Agenda Item	7.8
Report No	PLN/046/23

HIGHLAND COUNCIL

Report Title: 21/01921/S36: Garvary Wind Farm Limited, C/O Coriolis Energy
Land 4600M NE of Invershin Community Hall, Invershin.

Title	Figure 2.1a: Site Layout
Project No.	1620014511
Site	Garvary Wind Farm AIR
Client	Garvary Wind Farm Limited
Date	November 2022
Scale	1:25,000 @ A3
Issue	1
Drawn by	BE

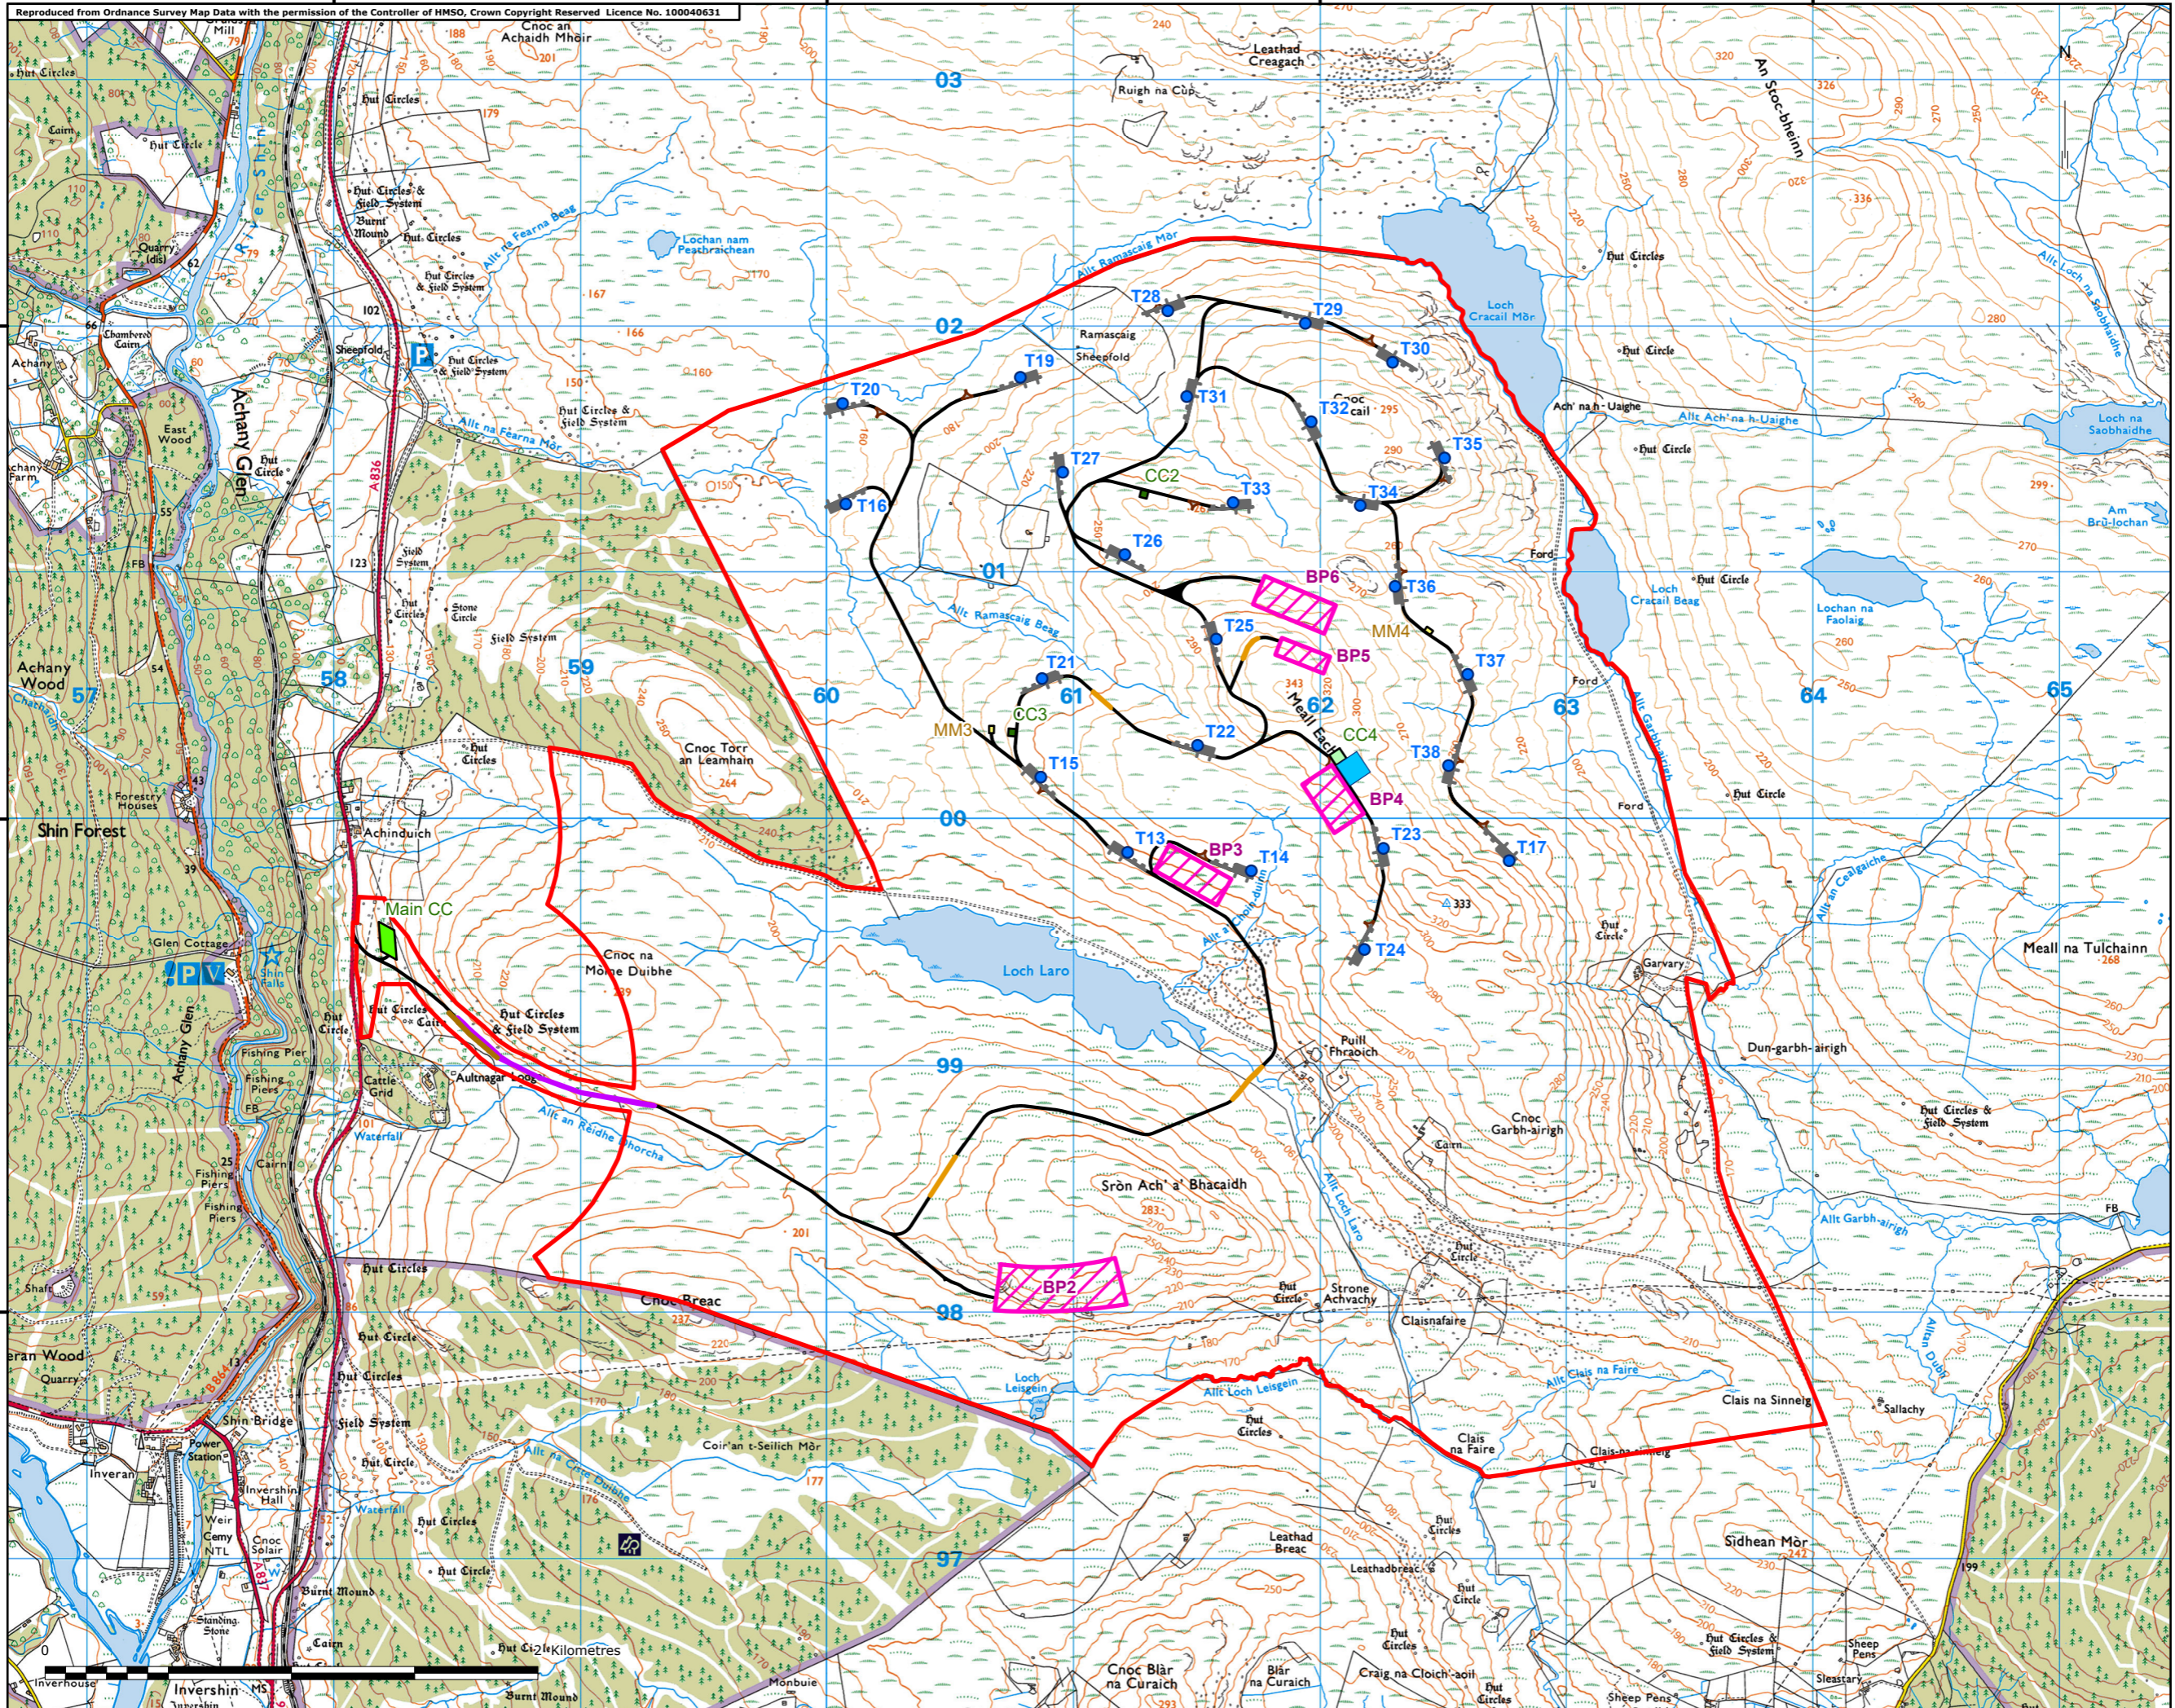
3.1 The Highland Council was consulted in April 2021 on the application for Garvary Wind Farm by the Scottish Government's Energy Consents Unit (ECU) under Section 36C of the Electricity Act 1989 (as amended), to which the Council subsequently objected in February 2022 under the Scheme of Delegation on the grounds of detrimental landscape and visual impacts, and detrimental impacts on the Dornoch Firth National Scenic Area (NSA) Following the Council's objection, the applicant requested permission to revise the proposal's design and layout to address the Council's concerns by submitting Additional Environmental Information, rather than withdrawing the application or requesting to have it referred to the Planning and Environmental Appeals Division (DPEA) for a public inquiry. The legal basis for this course of action was laid out by the applicant's solicitors to, and agreed in writing by, the ECU in April 2022 and therefore the lawfulness of the process is not a matter for this assessment. The revisions were then submitted as Additional Environmental Information on 13 January 2023, with the application now amended from a proposal of 37 turbines to 25, with Turbines 1 to 12 removed from the scheme and Turbine 17 relocated to the east of the application site.

3.2 Otherwise, much of the scheme remains unchanged except where infrastructure requirements are amended as a consequence of the revision, which are highlighted below. The application still seeks a 30 year permission and the three blade turbines are still anticipated to generate between 5 – 6MW of energy each, while the maximum blade tip height of 180m and indicative 105m ground to hub heights and 150m rotor diameters are the same. The proposed turbines would have internal transformers and associated switching gear at their respective locations, while the expected operational life is 30 years. The windfarm as a whole is expected to generate approximately 150MW of power, reduced from 222MW. The application includes associated ancillary works and infrastructure consisting of:
